<b>Application No.</b>	<b>Proposed Use(s) / Development(s)</b>	<b>Date of Consideration</b>	<b>Approval Conditions</b>
1.	A/NE-KTS/460	Proposed Houses	21.12.2018	(a), (b), (c), (d) and (g)
2.	A/NE-KTS/466	Proposed Residential Development and Minor Relaxation of Plot Ratio and Building Height Restrictions	13.12.2019	(a) to (f)
3.	A/NE-KTS/528	Proposed House Development	9.6.2023	(a), (b), (c), (d) and (g)
4.	A/NE-KTS/525	Proposed Residential Development and Minor Relaxation of Plot Ratio Restrictions	27.10.2023	(b) and (c)

**APPLICATION FOR PERMISSION  
UNDER SECTION 16 OF  
THE TOWN PLANNING ORDINANCE  
(CAP. 131)**

**Proposed ‘House (not elsewhere specified)’ Development and Proposed Minor Relaxation of Maximum Plot Ratio Restriction in “Residential (Group D)” Zone at Lots Nos. 407 S.A ss.2 S.A and 408 S.B ss.1 RP in D.D. 94, Hang Tau Tai Po, Kwu Tung South, New Territories (S.16 Planning Application TPB Ref: A/NE-KTS/538)**

Figure 6b - Underground E&M Utilities Room Plan

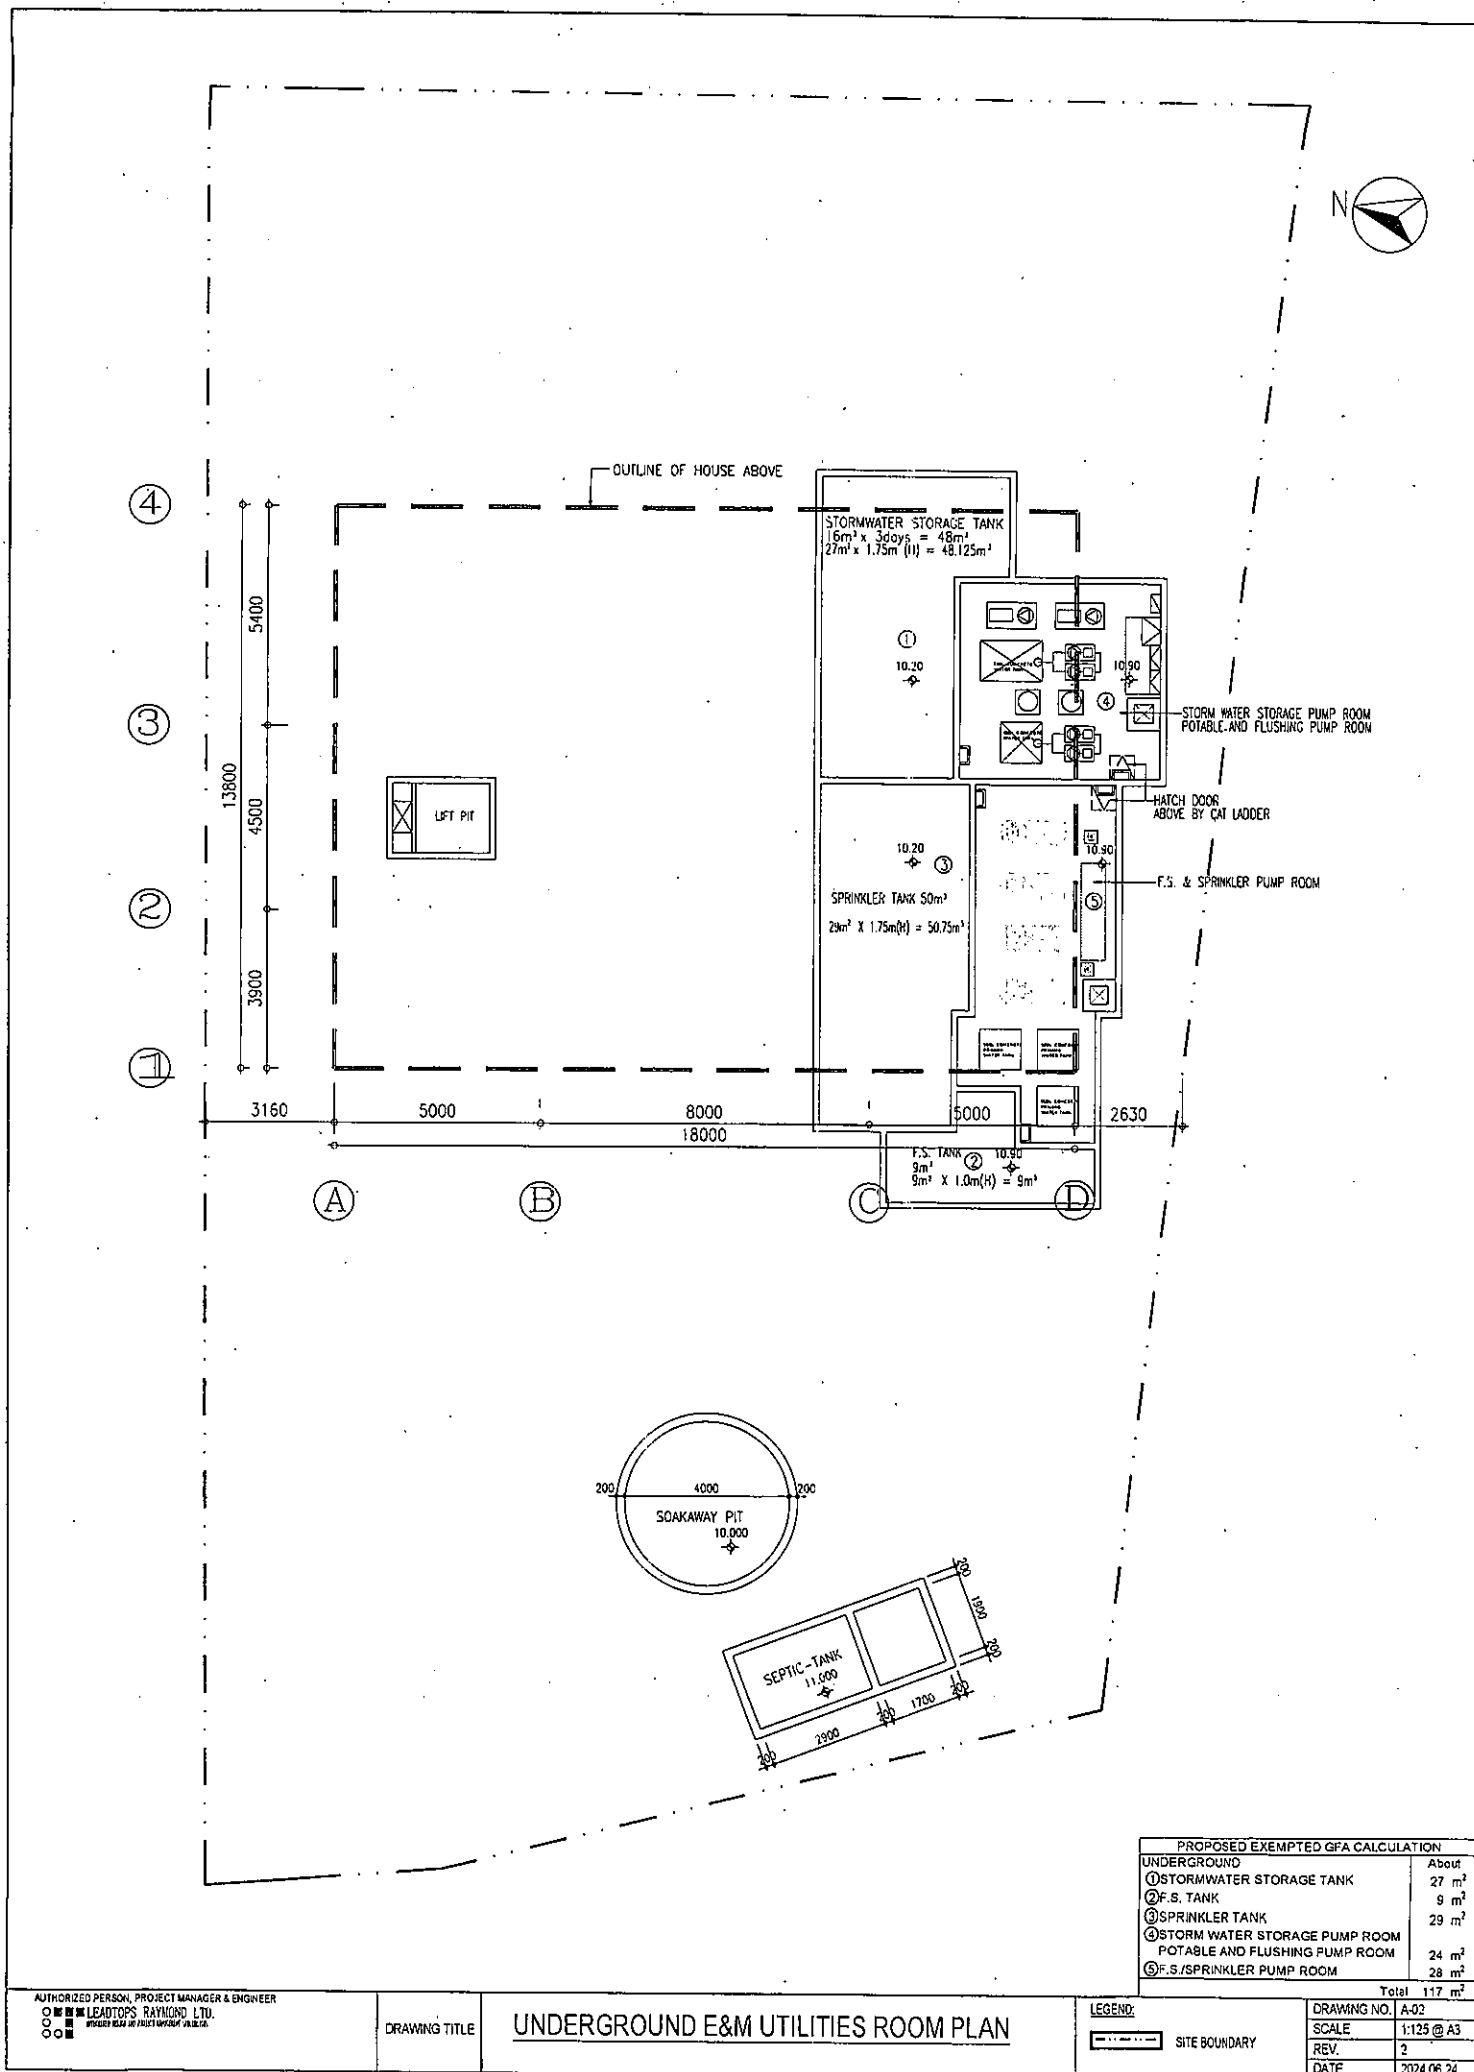
1.	<p>Based on the information provided, in particular of the height, the underground E&amp;M facilities and water tanks may be considered as a storey under the Buildings Ordinance.</p>	<p>The proposed heights of the F.S. &amp; sprinkler pump room, stormwater storage pump room and portable &amp; flushing pump room have been reduced to 2.1m, while the height of the stormwater storage tank, F.S. tank and sprinkler tank are now being reduced to 2.8m. Due to the above changes, a set of revised plans, i.e. <b>Figures 5b, 6b, 7a and 11a</b>, is now attached in <b>Annex A</b> to replace their original ones. As a result, the sizes of these ancillary facilities have been amended and an additional GFA of about 12m<sup>2</sup> will be resulted accordingly.</p>

Figure 6c - Underground E&amp;M Utilities Room Plan

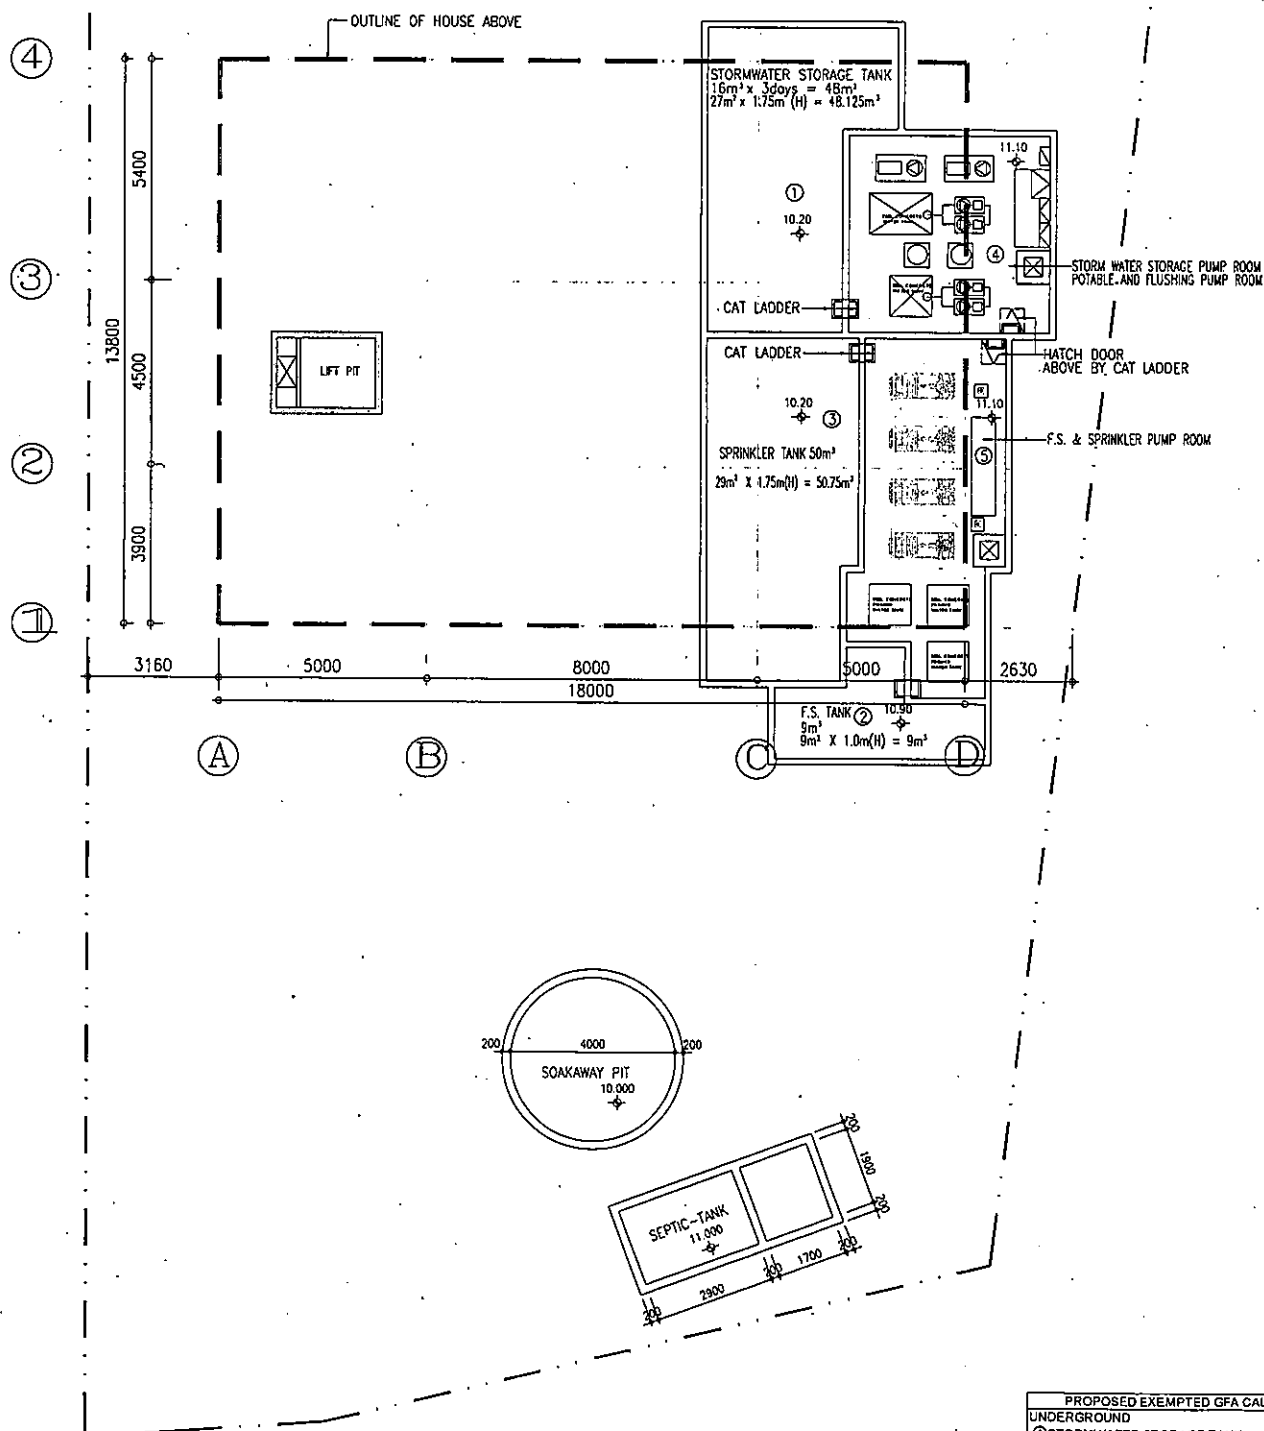
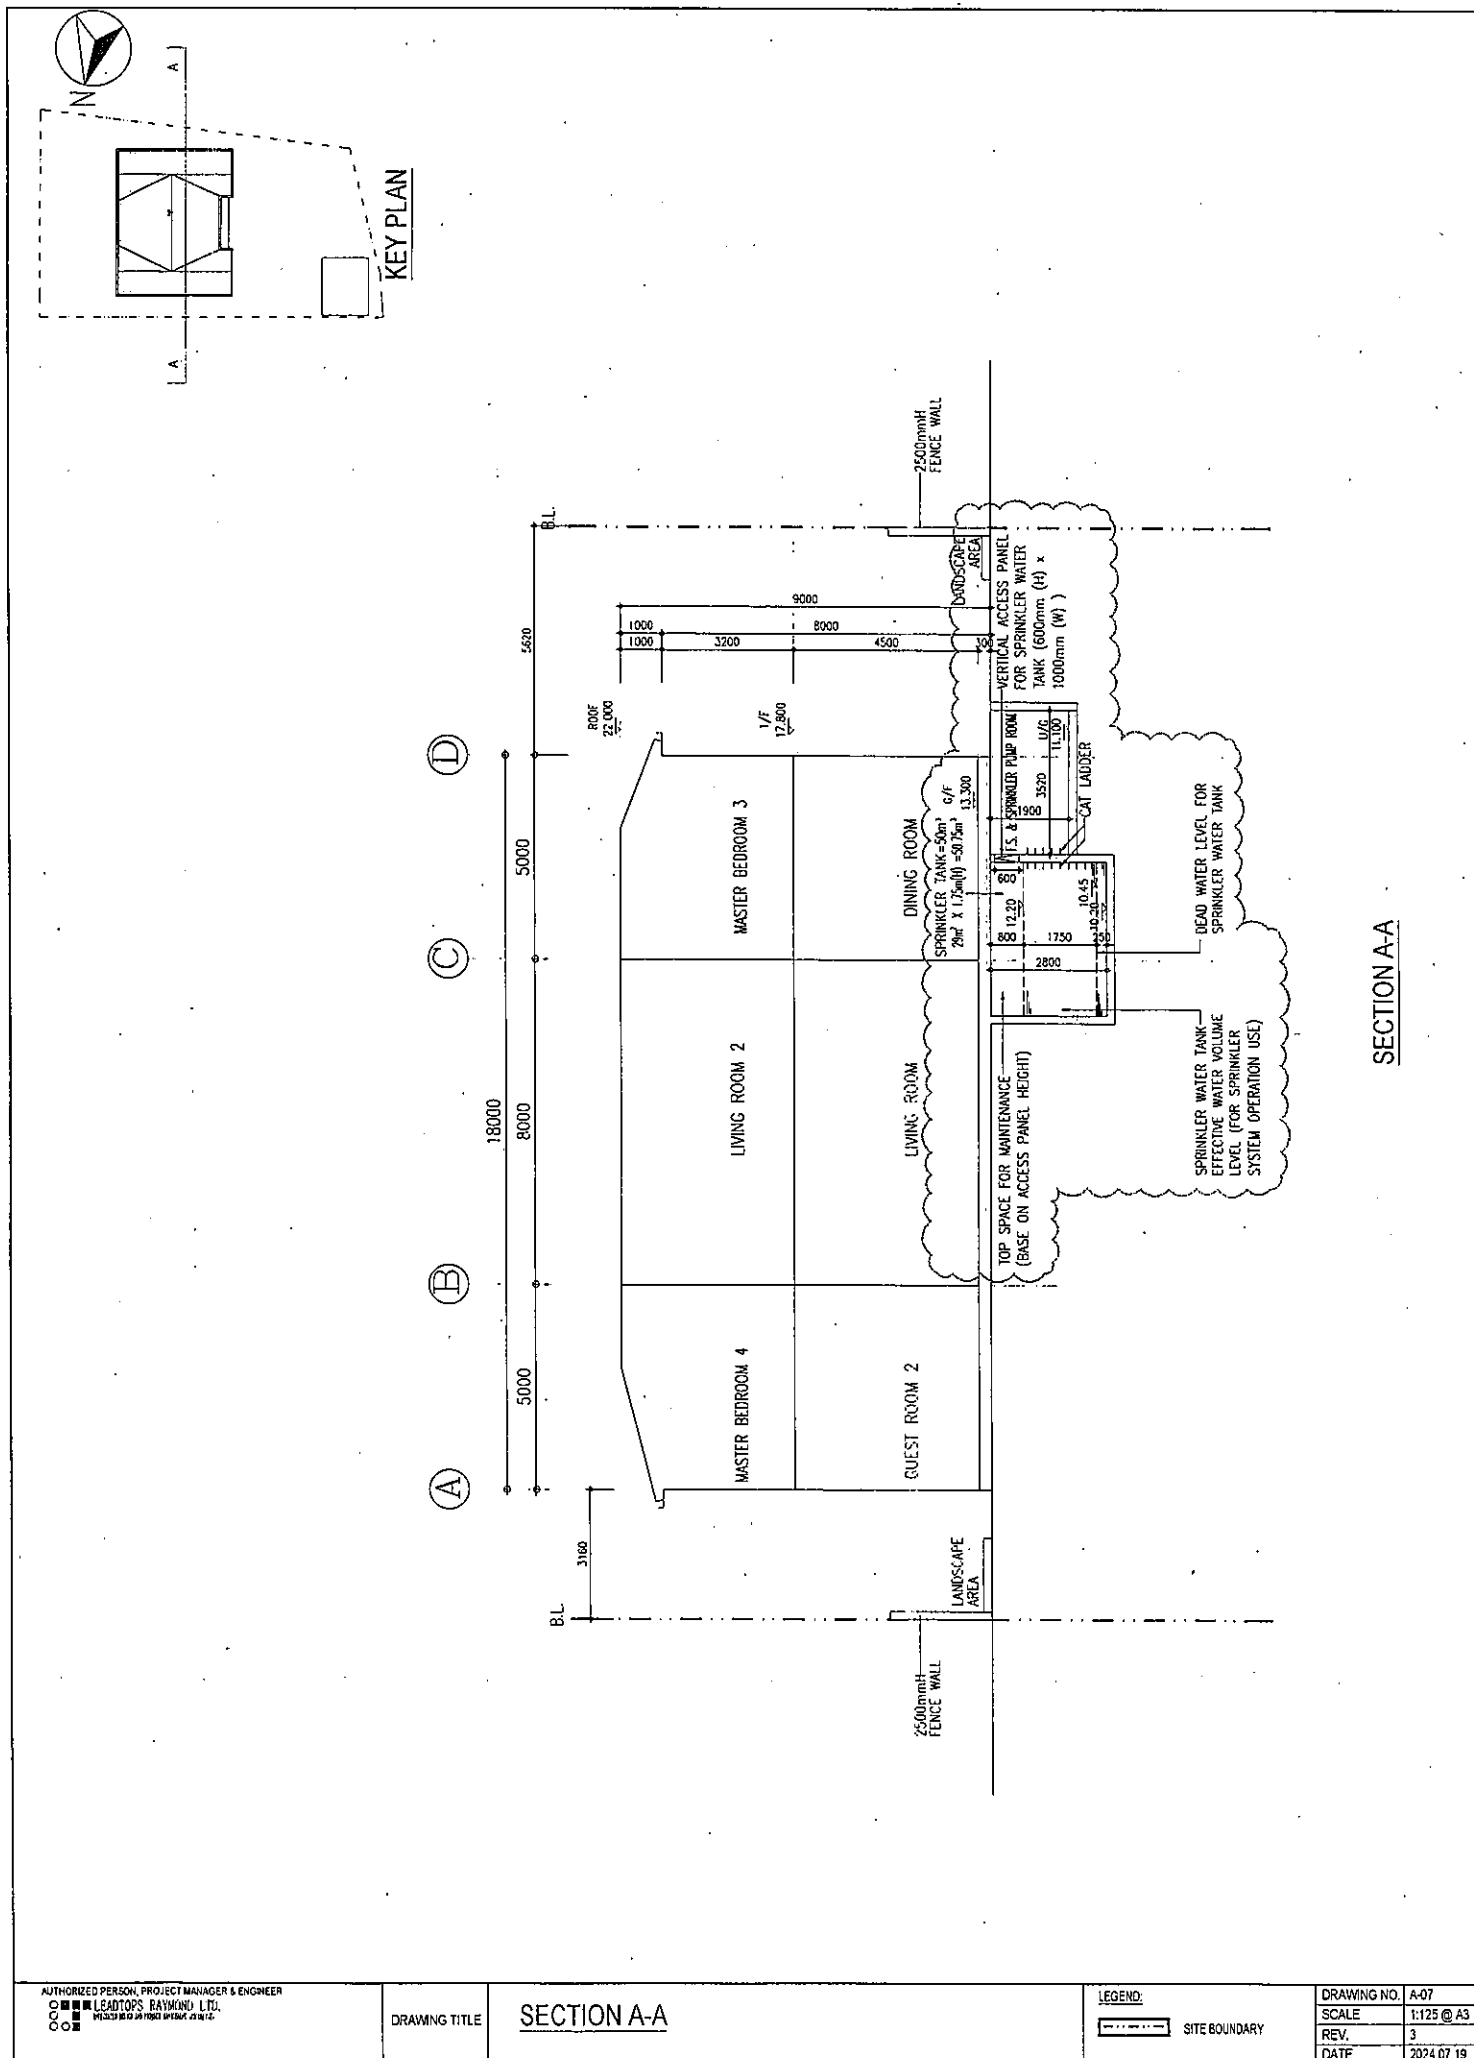
- i. Response-to-Comments ("R-to-C") Table (**Table A**) dated 22.7.2024; and
- ii. A set of revised plans, i.e. **Figures 6c** and **11c**, as attached in **Annex A** to replace their original ones.
